REQUEST FOR PROPOSAL (RFP)
Langley AFB Multiple Award Construction Contract (MACC)
AMENDMENT 01

PROJECT NUMBER: MUHJ 10-4096

PROJECT TITLE: Repair Nor'Easter Damage, Floors/Walls/Ceiling/ Utilities/Roof, Facility 750

ADDENDUM NO: 1
MACC SOLICITATION NO: MUHJ 10-4096
PROJECT NO. & TITLE: MUHJ 10-4096 REPAIR NOR'EASTER DAMAGE,
FLOORS/WALLS/CEILING/UTIL/ROOF, F. 750

N →
BUILDING 750
 1st FLOOR
 NOT TO SCALE

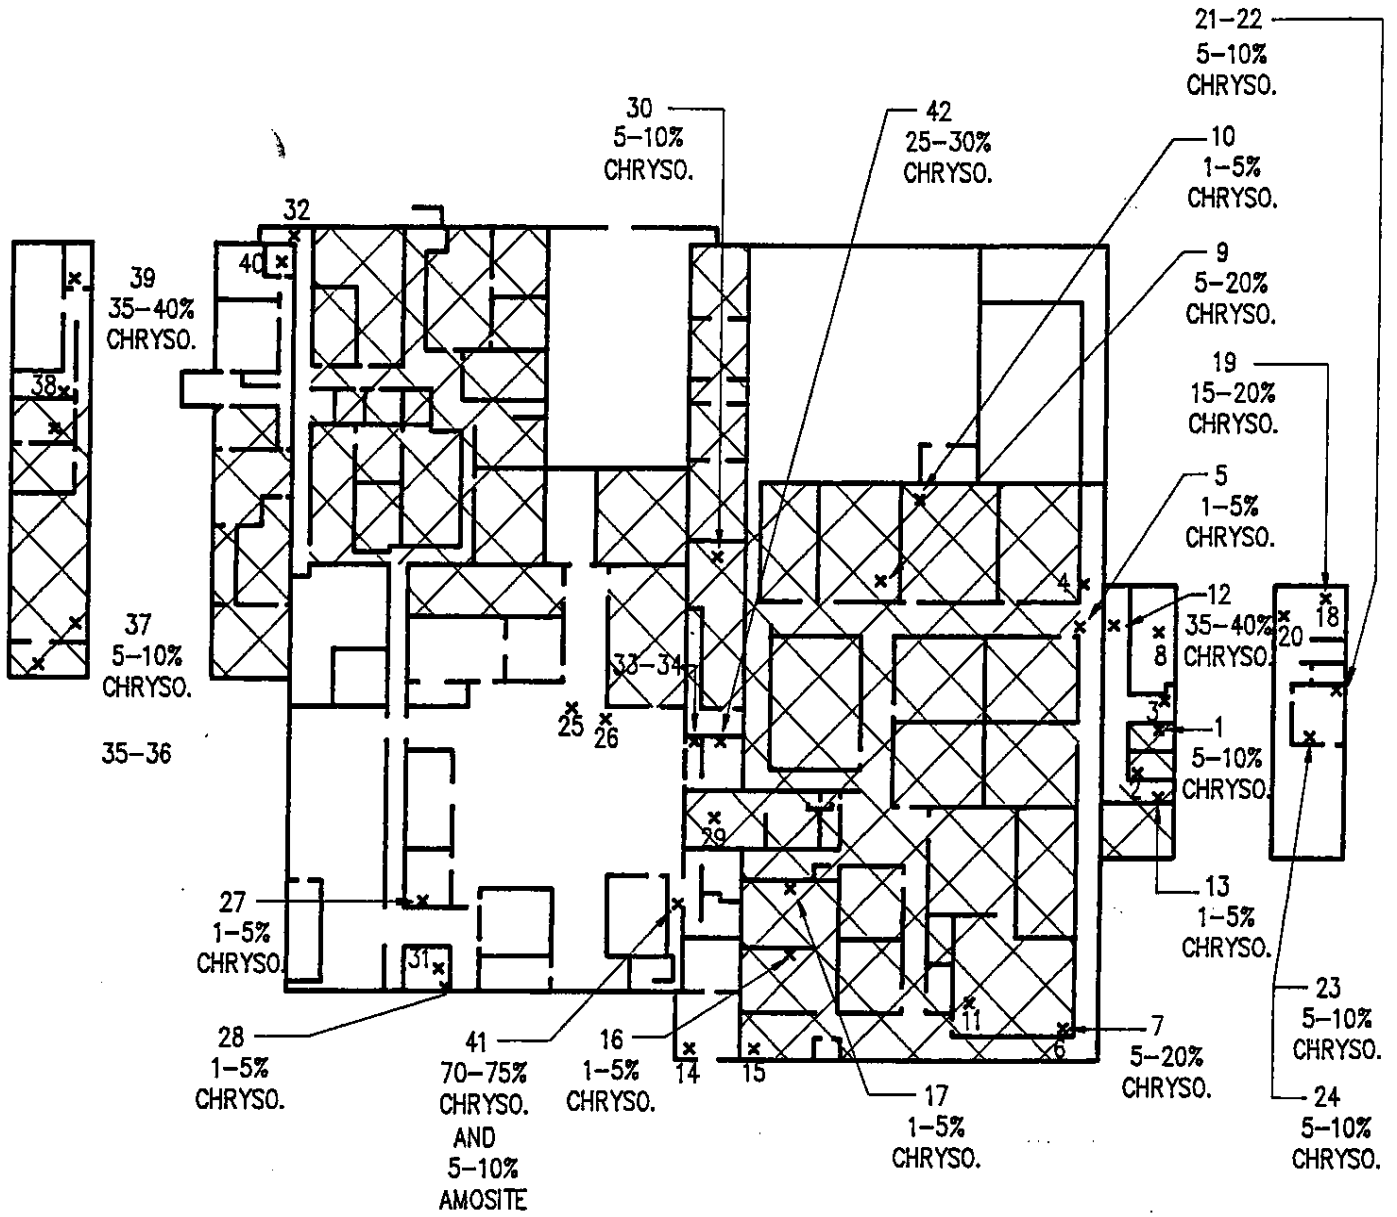
14. The Hazmat report states that asbestos and LBP is present and gives room numbers on page 2 and 3 but the plan on the first page does not have any room numbers. Please provide the plan with the corresponding room numbers that was used during the survey.
Unknown – all available information provided to Contractors in initial report. Conduct an asbestos survey on areas being worked on.
